Volvo 850 / C70 I / S70 / V70

Item no. 3151 269 332

Fig. 1: Clutch release bearing

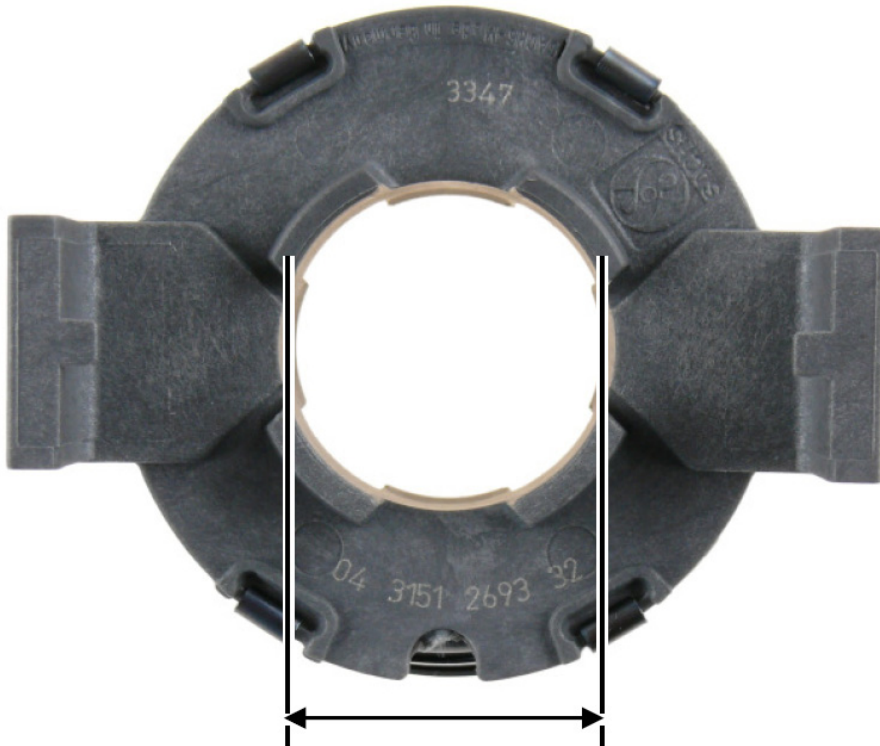
The profile of the guide tube is tapered. The diameter is largest on the engine-side end of the guide tube. The inside diameter of the clutch release bearing is 0.2 mm less than on the previous version of the clutch release bearing (item no. 3151 216 031).

- ➔ Less clearance between the clutch release bearing and the guide tube.
- ➔ Vibration noise minimized.

The clutch release bearing may not slide smoothly on the guide tube during assembly. This has no negative effect in the running area of the clutch release bearing.
